September 20, 2021

**Subject: ITB #1991-B: Kedron Dam Spillway & Intake Structure Repairs
Addendum #1**

Attachment 2

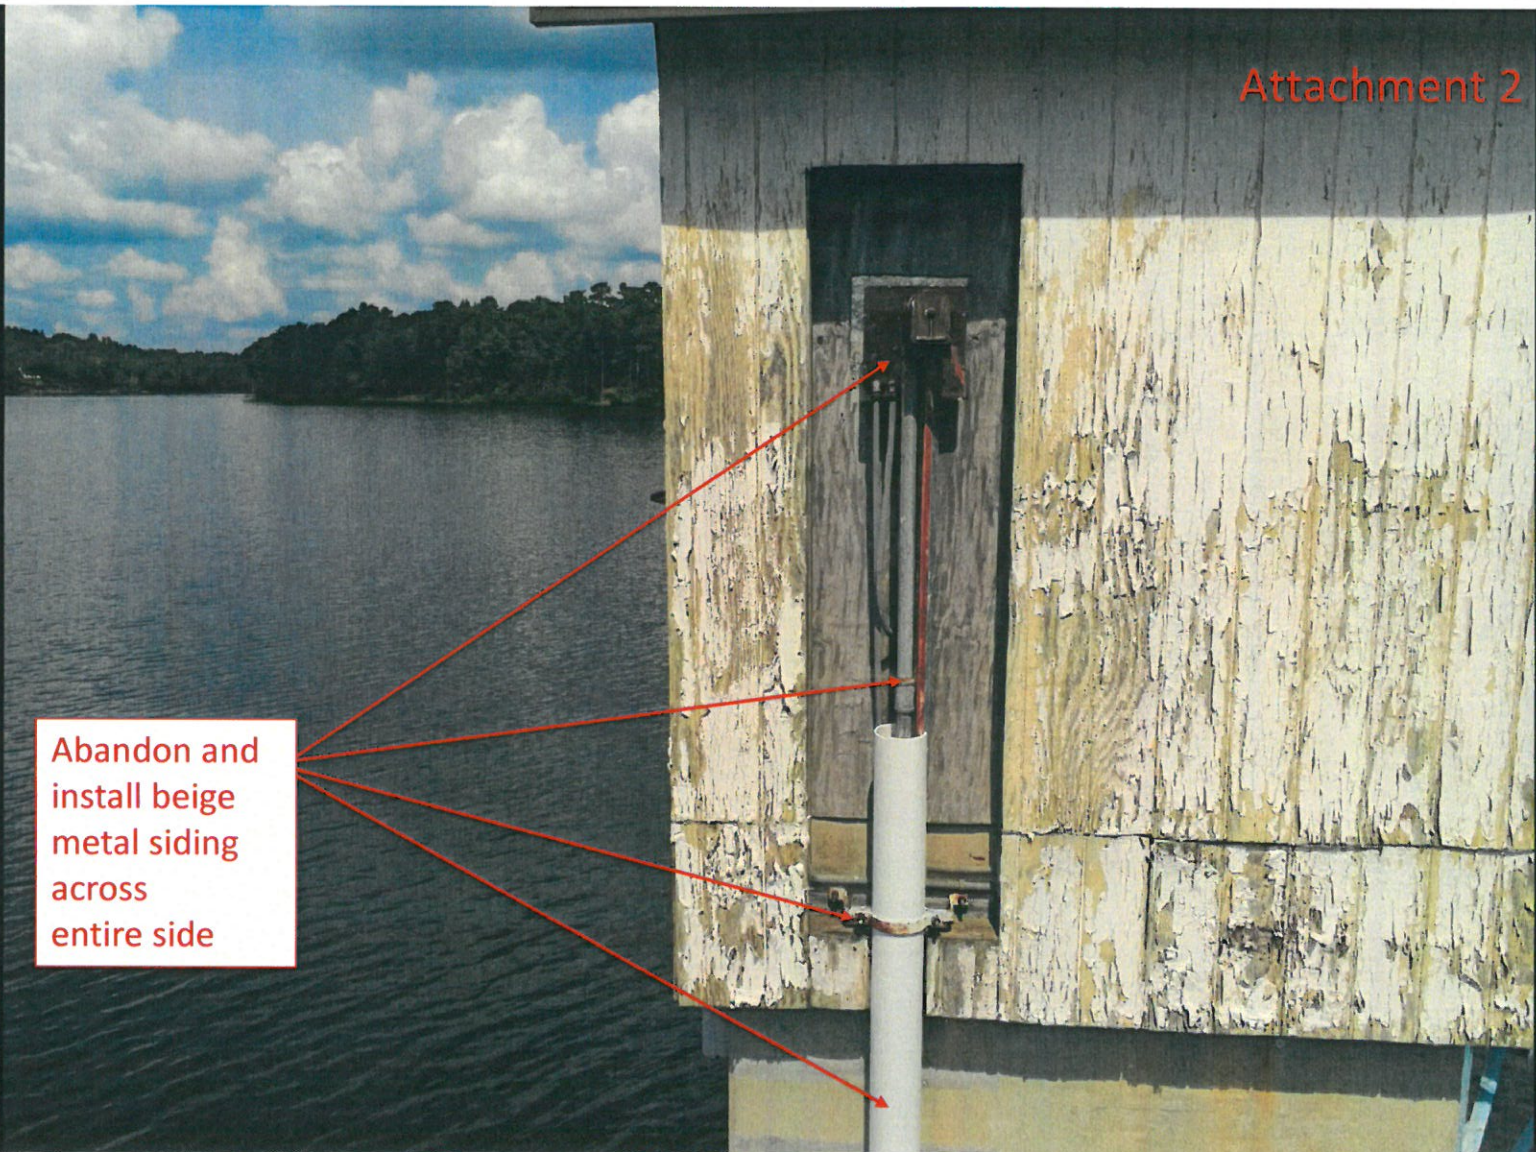
Abandon and
install beige
metal siding
across
entire side

Attachment 3

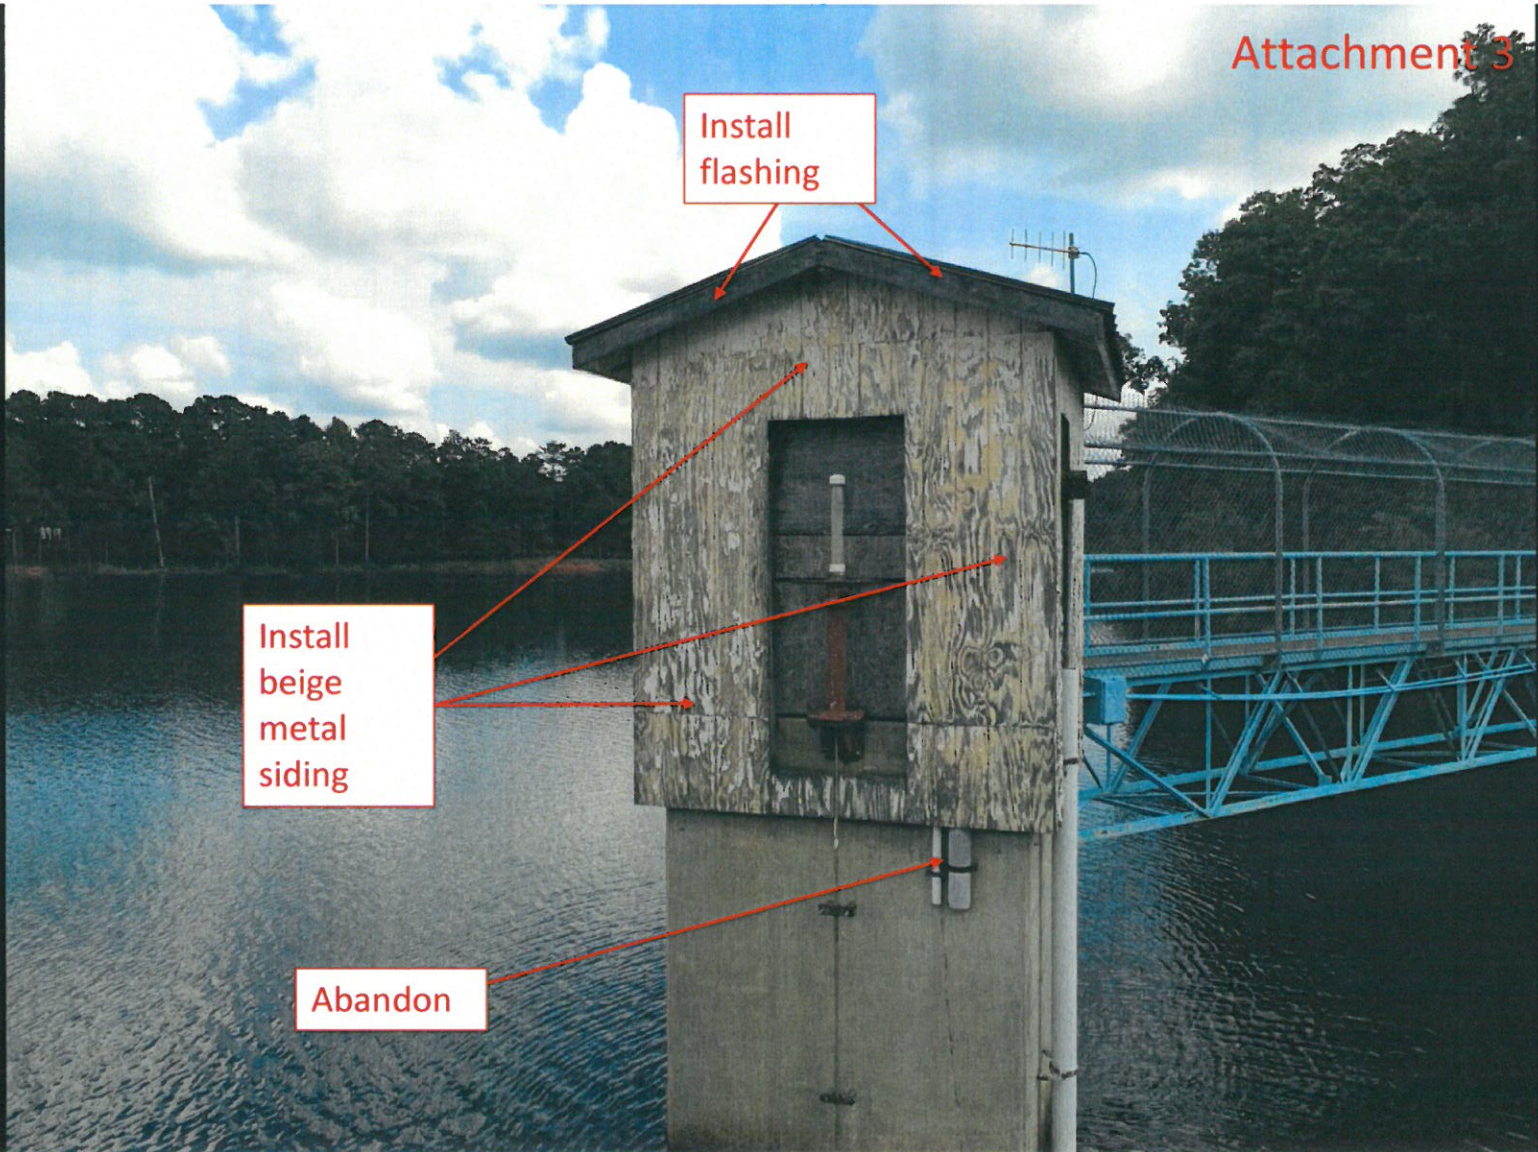
Install
flashing

Install
beige
metal
siding

Abandon

Attachment 4

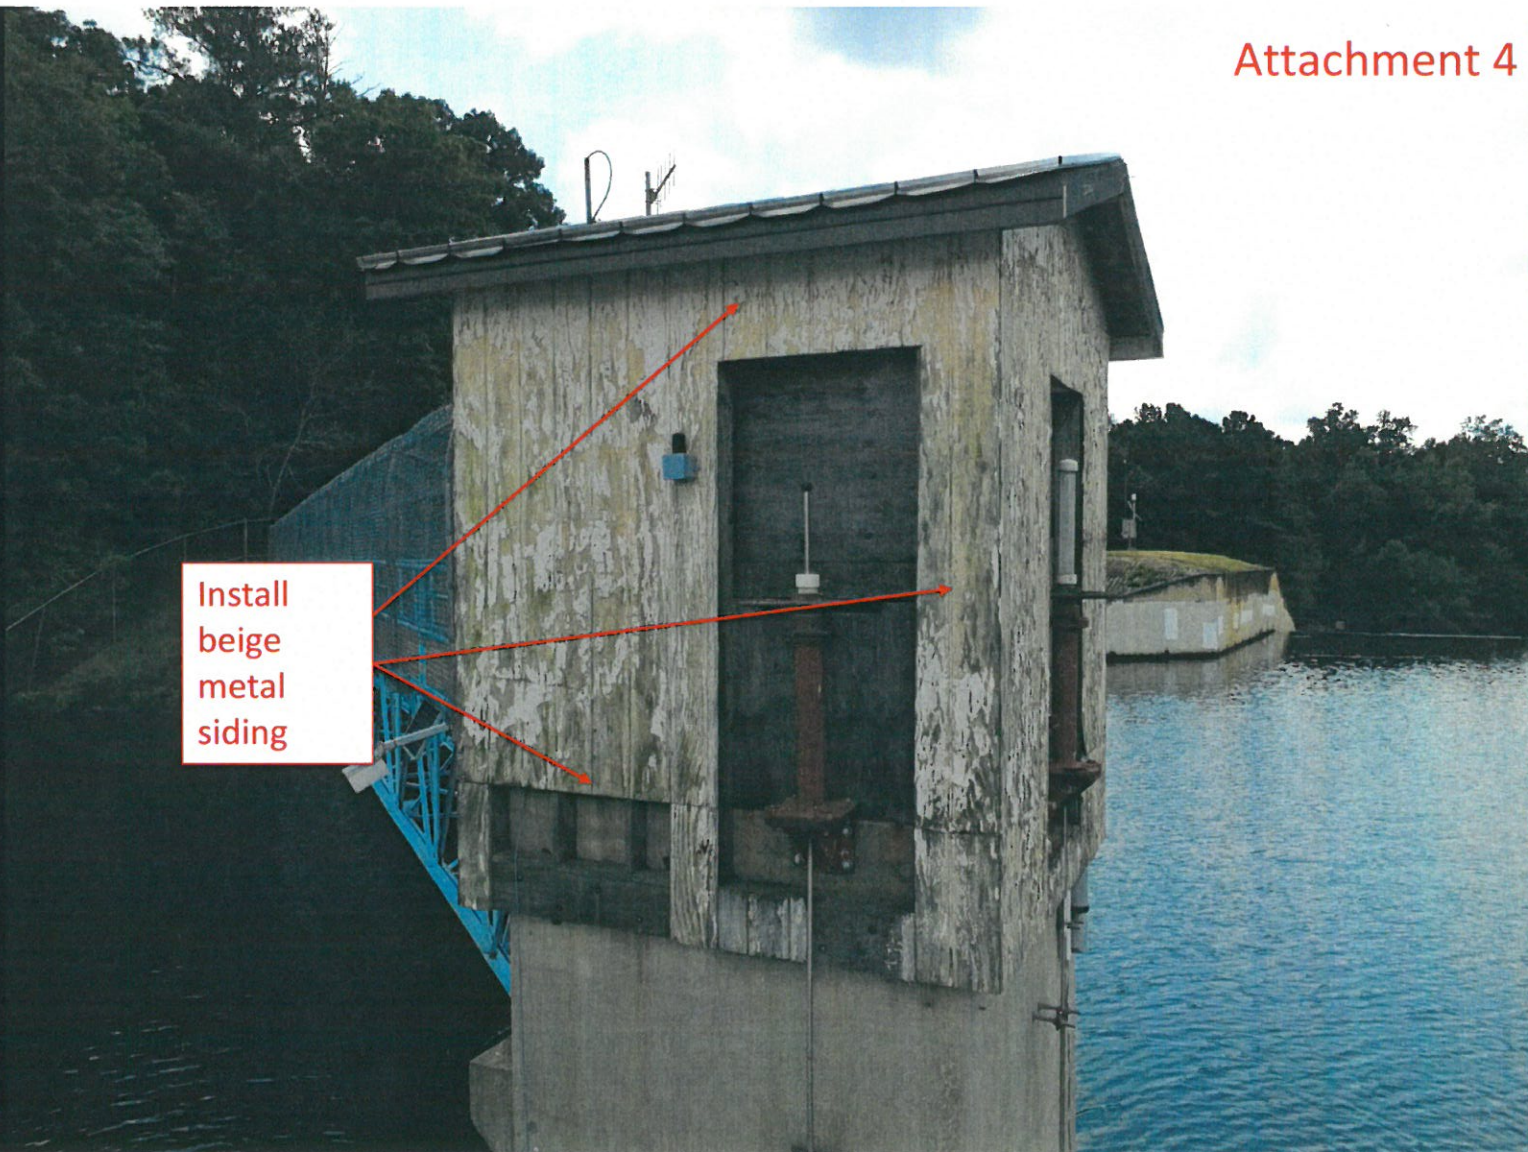
Install
beige
metal
siding
